Tapping from A-Pillar Trim

20MY Defender

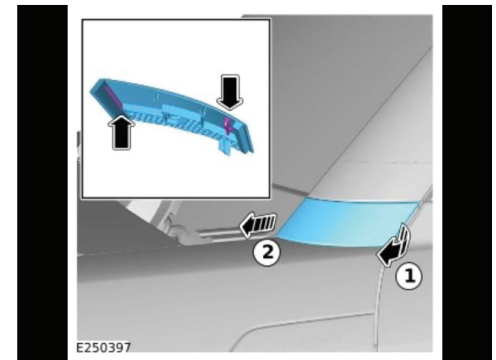
- A customer may report a tapping type noise from the A-Pillar area while driving at highway speeds.

- A limited number of New Defender vehicles may present a tapping noise concern from the exterior A-Pillar finisher contact points on the inner bracket at speeds between 37 – 75 mph (60 – 120 km/h).

- Service Action N472 is being published to proactively address this concern, by installing felt tape between the A-Pillar finisher and the finisher retaining bracket.
- Please note care must be used when removing the finisher retaining screw cover to avoid damage. A video has been provided within the bulletin procedure to aid in the removal and installation of the cover.
